Re: Addendum Soil and Ground-Water Investigation Work Plan
Atlantic Richfield Company Station #771
899 Rincon Avenue
Livermore, California
ACEH Case RO0000200

Project No. 06-82-608

Re: Addendum Soil and Ground-Water Investigation Work Plan, Atlantic Richfield Company (a BP affiliated company) Station #771, 899 Rincon Avenue, Livermore, California. Case No. RO0000200.

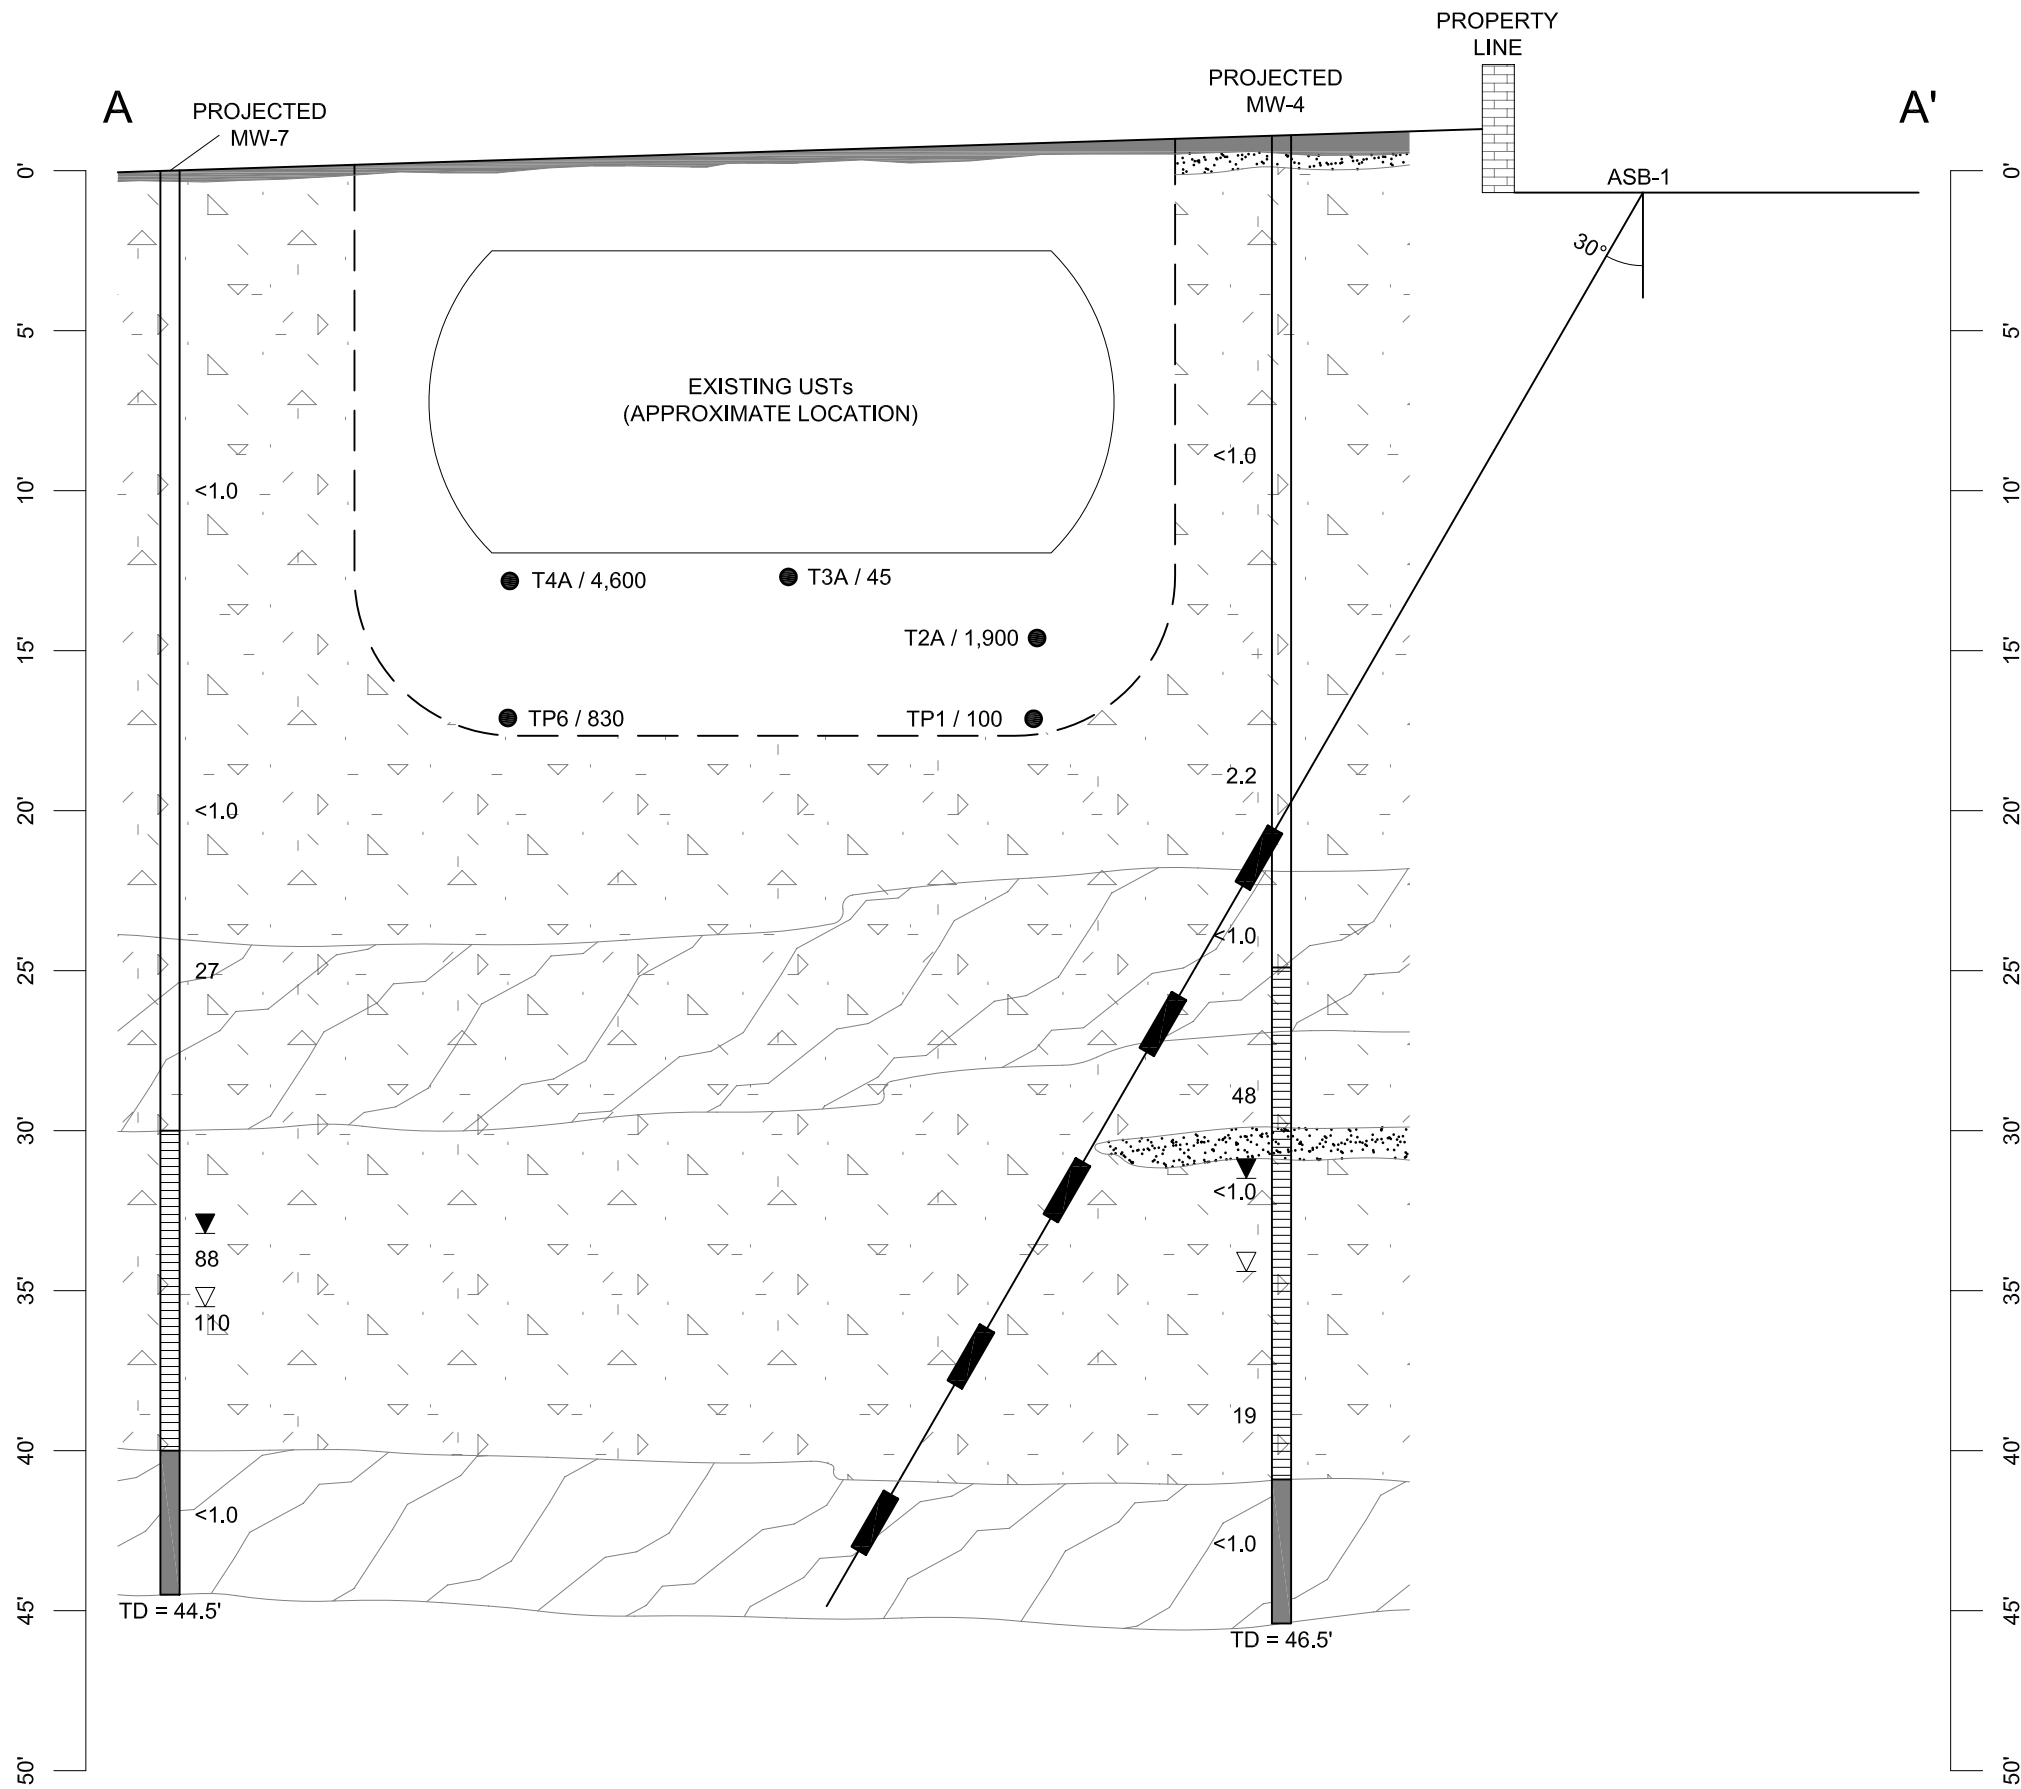
Accordingly, it is proposed that angled soil boring ASB-1 be initiated off-site on the neighboring Shopping Center property to the south at the location depicted in Drawing 1. The angled boring will trend in a northerly direction at an angle of approximately 20 and 30 degrees from vertical and proceed underneath the former and current UST location. The angled boring should facilitate the collection of soil samples post soil vapor extraction remedial activities (system operational in 1994 and 1995) and allow for further vertical definition of impacted soil below the former USTs. A geologic cross section depicting ASB-1, the current USTs and former UST excavation, and relevant historical soil sample analytical data is provided in Drawing 2. As shown in Drawing 2, the location of ASB-1 was determined based on the safety requirement to maintain a minimum distance of 10 feet between the current USTs and the boring.

Similar to proposed off-site ground-water monitor wells MW-12 and MW-13, ASB-1 will be installed using a hollow steam auger drilling technique. ASB-1 will proceed to a distance of approximately 50 feet which corresponds to a depth of 43 feet below land surface (bls) and extends the boring below the southerly portion of the former UST excavation. Soil samples will be collected at
